CITY OF SUFFOLK

ADDENDUM NO. 2

City of Suffolk
IFB 2014-00108-JS
July 3, 2014

Signage for E911/Municipal Center

SIGN TYPE

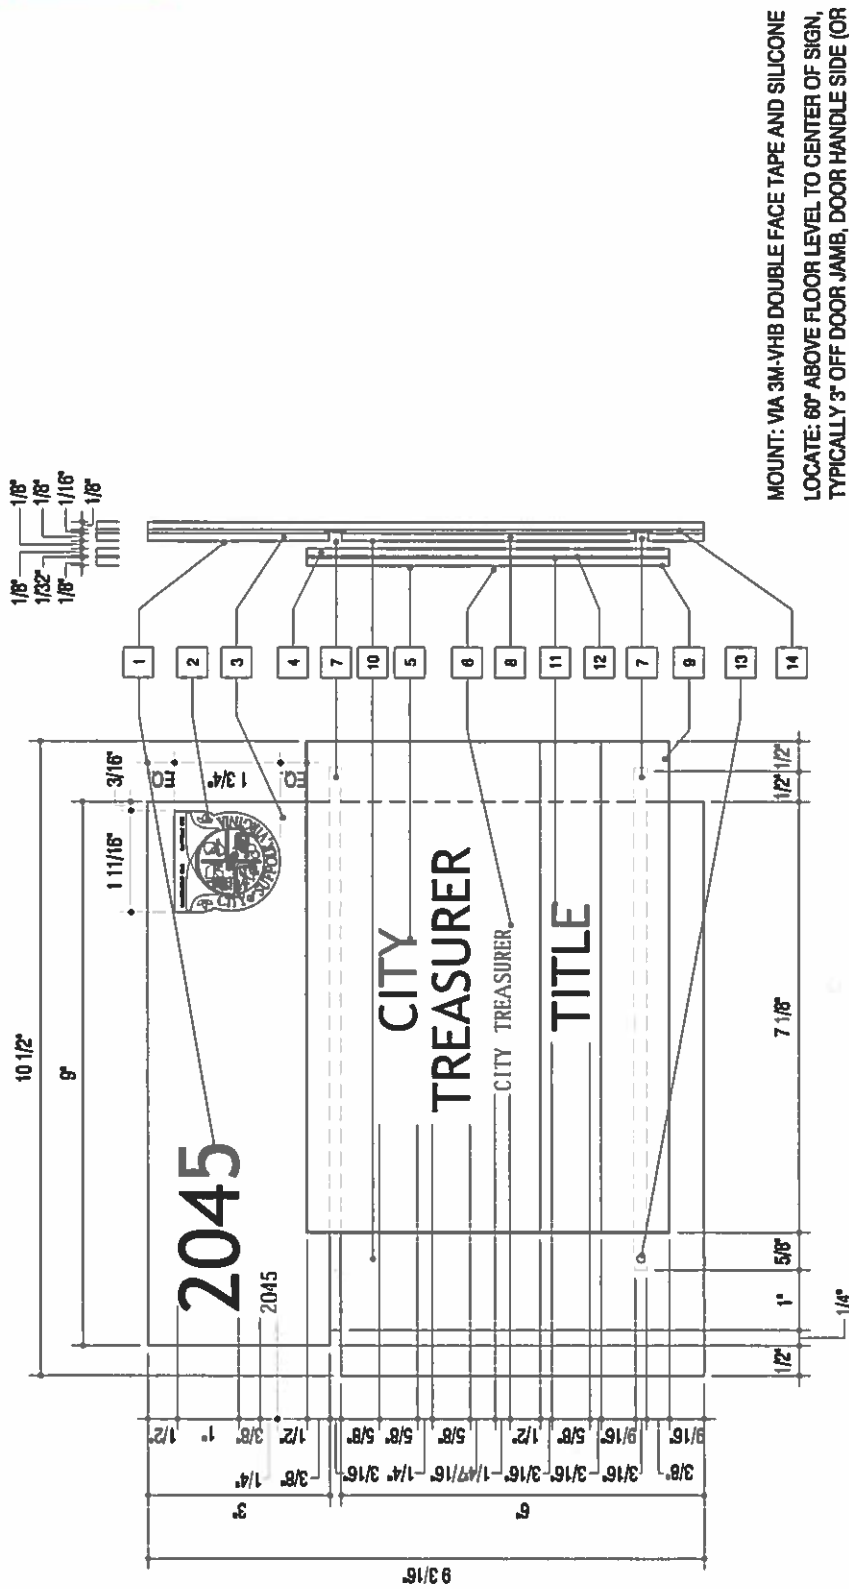
The stainless steel bar and rail:

Q: In the rail and bar on piece, if not how to they attach together?

Q: Can a side detailed view of these 2 pieces?

A: The bar and rail can be fabricated as a single piece or fabricated out of two pieces at the option of the contractor. Attachment method for two piece option is determined by the sign fabricator.

A: Attached to this addendum.

- 6 ADA BRAILLE - INTEGRAL WITH BACKGROUND
- 7 3/16" x 1/4" STAINLESS STEEL BAR WITH 1/32" x 5/16" CONCEALED RAIL; HAND BRUSH WITH 240 GRIT PAPER - HORIZONTAL GRAIN; ATTACH TO COMPONENT 4 WITH ADHESIVE. SLIDE INTO NOTCH IN COMPONENT 8 AND 14.
